Z-27
(2013)
REVISED SITE
PLAN

PETITION NO: Z-27

ZONING COMMENTS:

STORMWATER MANAGEMENT COMMENTS

2" = FULL SCALE
1" = HALF SCALE
0 10 20
FEET
P.L. NO.:
DRAWING TITLE
ZONING PLAN

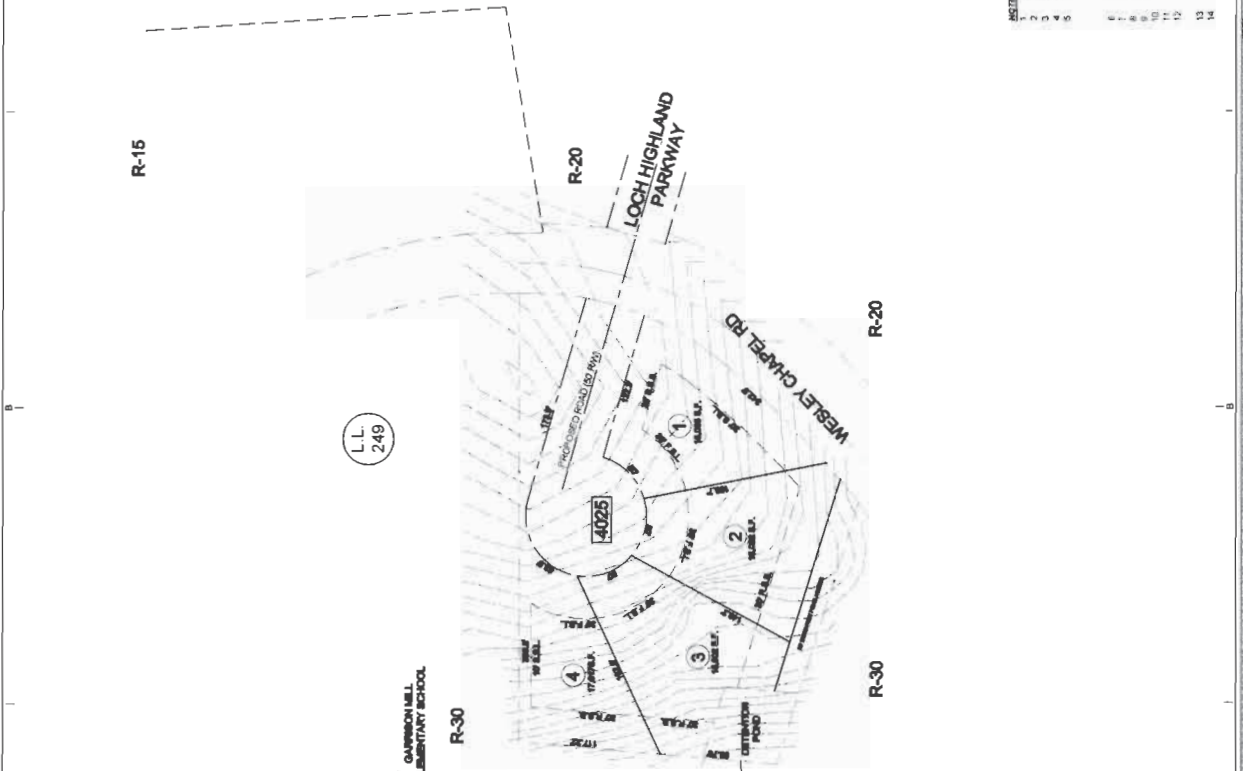
- No Stormwater controls shown _____
- Copy of survey is not current – Additional comments may be forthcoming when current site conditions are exposed.
- No site improvements showing on exhibit.

1. This parcel is located to the west of Wesley Chapel Road and is bounded by the Robert Hicks Farm to the south and Garrison Elementary School to the north and west. Approximately a third of the site drains to the south along the right-of-way of Wesley Chapel Road. The remainder of the site drains to the southeast through the Robert Hicks Farm property. Stormwater conveyance through this parcel is limited. There is an existing 18-inch CMP culvert located at the property line that flows under an existing barn/shed. This pipe discharges into an existing farm pond with limited spillway capacity. Detailed hydraulic analysis will be required at Plan Review to verify no adverse impact to these offsite systems.

2. While the location of the detention pond is at the low point of the site, the proposed access from the right-of-way is along the southern boundary of the site and will require total clearing for maintenance access. This will eliminate any buffer for the adjacent property owner.

3. A pre- and post-development sediment survey will be required for the downstream farm pond.
